**REPORT UNDER SECTION 38 OF THE ROAD TRAFFIC ACT
(1994)**

**Active Travel Scheme
Headford, Co Galway**

Appendix D- Preliminary Drawings- Revised Drawing

Fig. 1

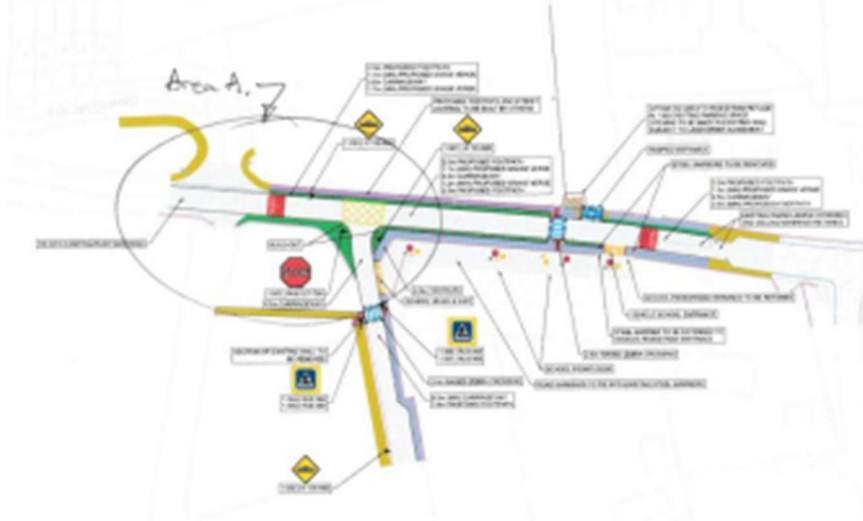
Area A on map above.

Would a roundabout be an option at the location at the entrance to the school. Or alternatively create a roundabout a few metres past the existing school entrance to create an appropriately sized roundabout to serve as a traffic calming measure and facilitate safe entrance to the school. This could also provide a turning point for cars that have travelled from the town side and want to turn and go back into Headford.
